**AMENDMENTS TO THE DRAWINGS:**

### **REMARKS**

1/11

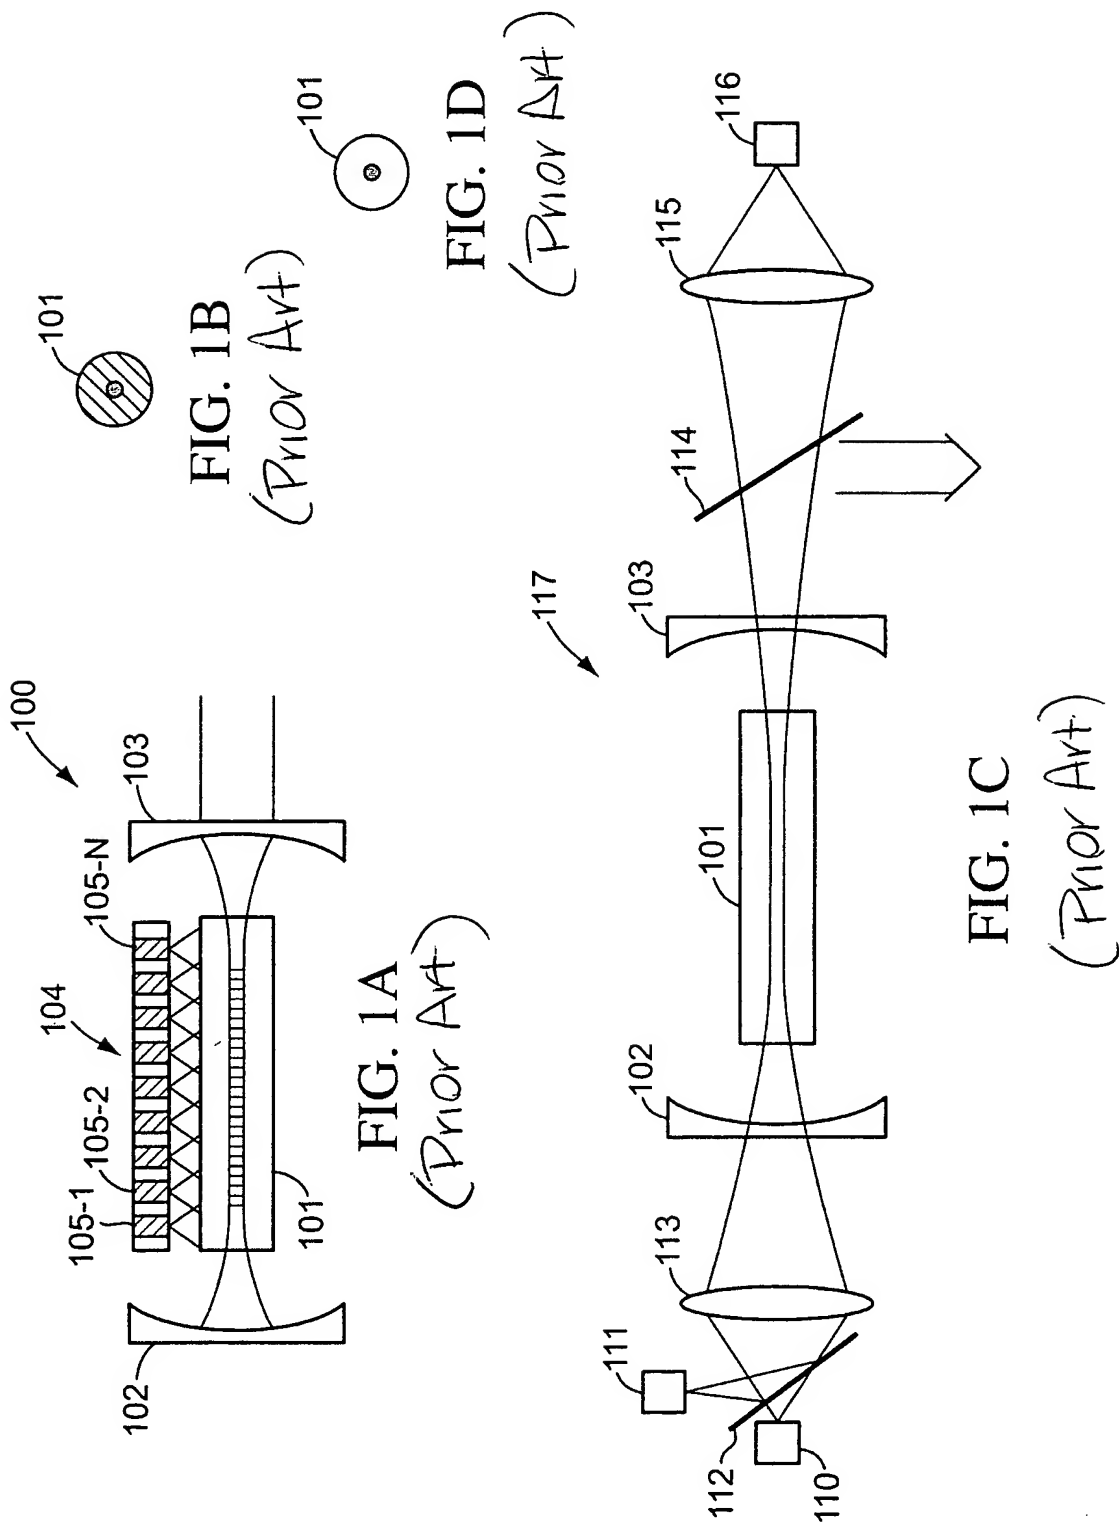
The attached sheets of drawings now include the legend “Prior Art” for Figures 1A-1F as requested by the Examiner on page 3 of the Office Action.

As suggested by the Examiner, Applicant has amended the drawings so that Figures 1A-1F are designated as “Prior Art.” Appropriate replacement sheets are attached to this response.
